From: Ben Wheeler
Sent: 29/05/2024 8:47:12 PM
To: Council Northernbeaches Mailbox
Subject: TRIMMED: Objection Submission to DA 2024/0534 Att - Megan Surtees
Attachments: Objection 14 Bassett BW .pdf;

RE: Objection to Proposed DA 2024/0534 – Address : Part Lot 33 Sec B DP 6195 14 Bassett Street, Mona Vale NSW 2103

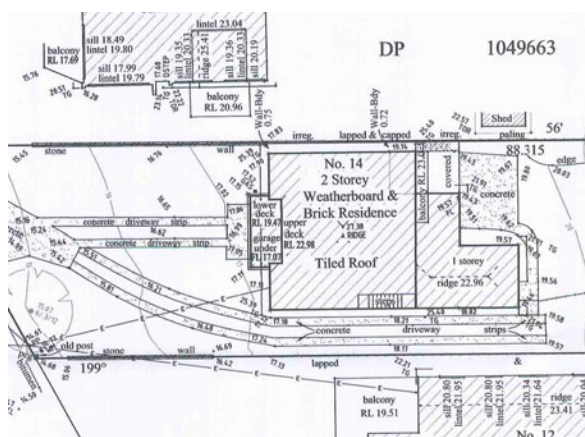
Our objection to the proposal comes from the impact that the current structure has imposed on our views, privacy, sunlight and amenity since its construction. I would like this to be noted as the change proposed with this DA, is a cumulative effect, to the enormous detrimental effects we personally have seen 14 Bassett St have on our property over the last 8 years.

By far the biggest impact that the current dwelling has on our property is regarding views, our morning sunlight and amenity of our property.

Here is a before and after picture of the view from our first-floor bedroom with a supporting survey prior to the current house being built on the property. The previous dwelling is marked in green for context.

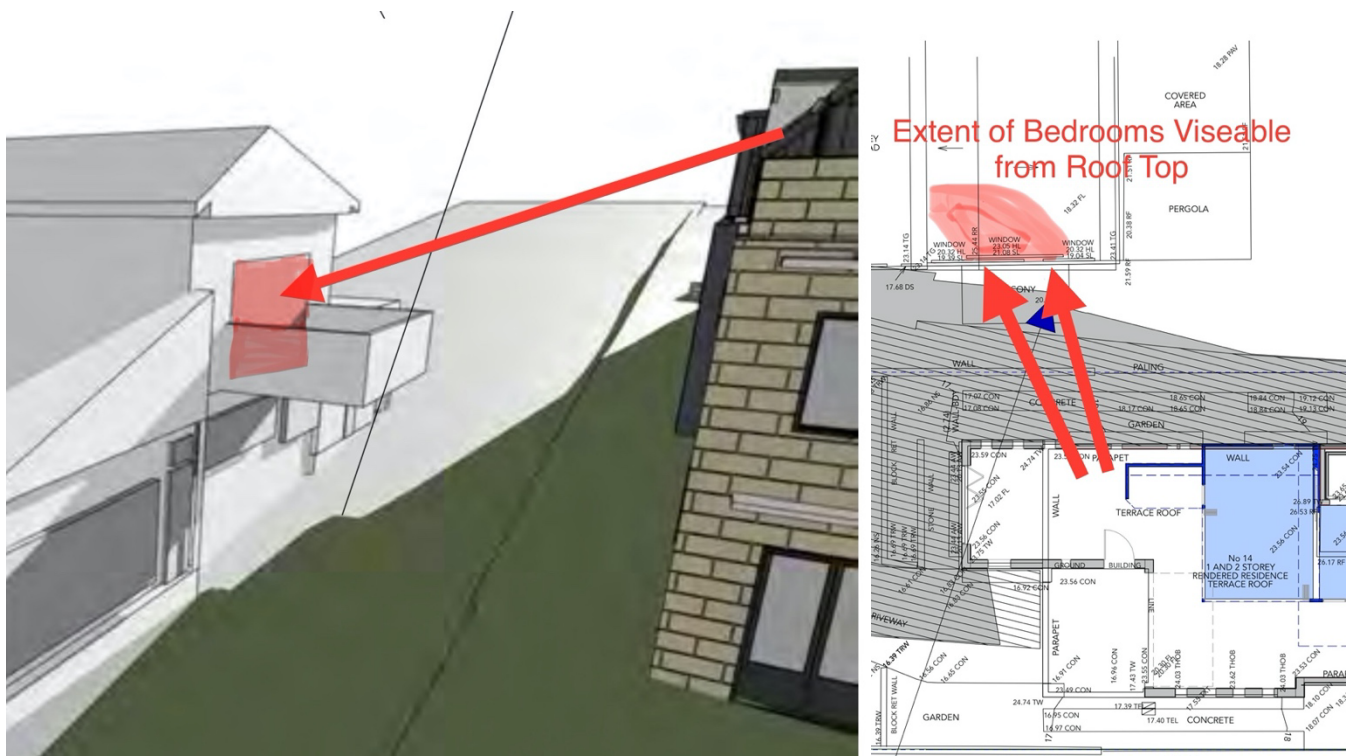
The roof top terrace will likely result in increased noise pollution and impact on the surrounding neighbours due to the lack of natural noise barriers. The likelihood of extended hours of useage particularly during evenings and weekends, exacerbates this issue, posing a continuous threat to neighbouring properties including our own.

The current proposal has an elevated view directly into two bedrooms on our second level as illustrated below and has not been designed for privacy. In addition, the side staircase and upper level remove privacy from our private open space. Critically, the submitted documentation does not demonstrate critical view lines from the proposed development into adjoining spaces and windows in section drawings.

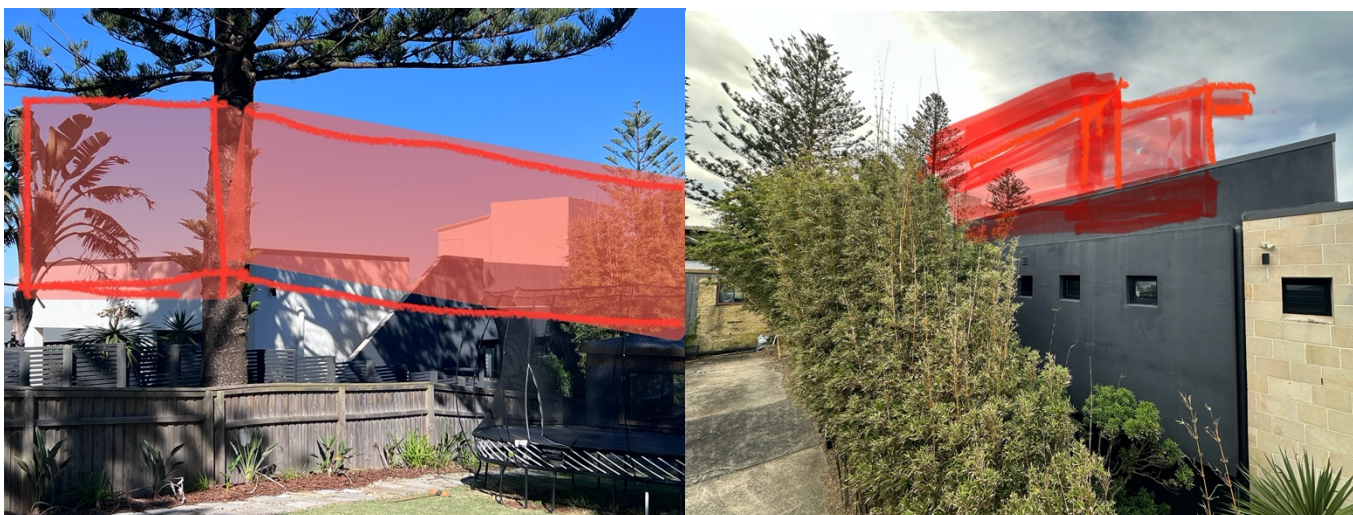
The sheer scale and nature of the existing structure is imposing as viewed from the side of our property due to a commercial/industrial appearance in nature more suited to a commercial district rather than a 'sensitive coastal location'. Architecture in these locations should fit sympathetically on the land. The lack of articulation between the current first and second level add to this, notwithstanding the substantially higher than standard ceiling height to both levels. Adding a third level to this already huge building has a massive impact visually from every angle, removing from our property much of our ocean and headland view and all the early morning sunlight

Current lift shaft and external shelter

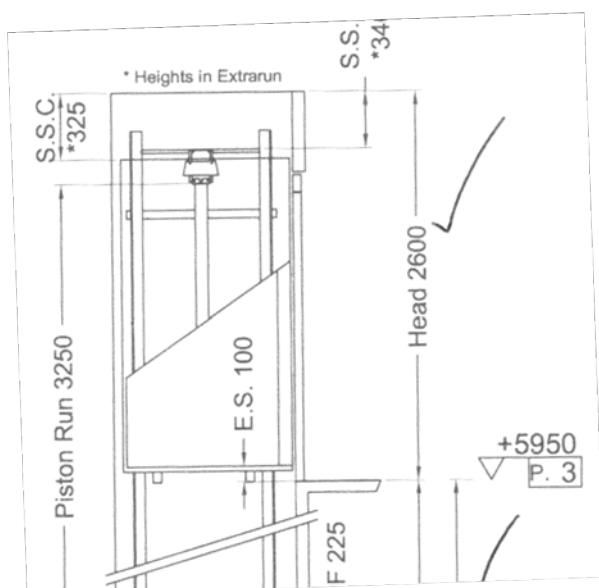
I assert that the ‘existing lift’ being used as an existing benchmark reduced level is not accurate due to it being misleadingly ‘an overrun’ under the CDC construction works. I was shown correspondence with council from a neighbour that this has been raised as an issue to Council prior to this DA being lodged. It would appear to us that this may not have been considered upon certification of the existing building.

A ‘lift overrun’ is required above the lift car for the mechanical function of the lift. As a licensed builder I have installed similar lifts into residential projects with a requirement of approximately 340mm in height above the lift car. If similar had been considered for 14 Bassett Street, this would have easily fitted within the second level of the home with a 3200mm ceiling height and without the requirement to go onto the roof terrace. I have attached the relevant part of the lift shop drawings by way of example. The lift overrun is also accessed by lifting the ceiling from within the lift car. It would therefore appear that an external shelter on the outside of the ‘lift overrun’ implies that this lift is intended to service the existing rooftop.
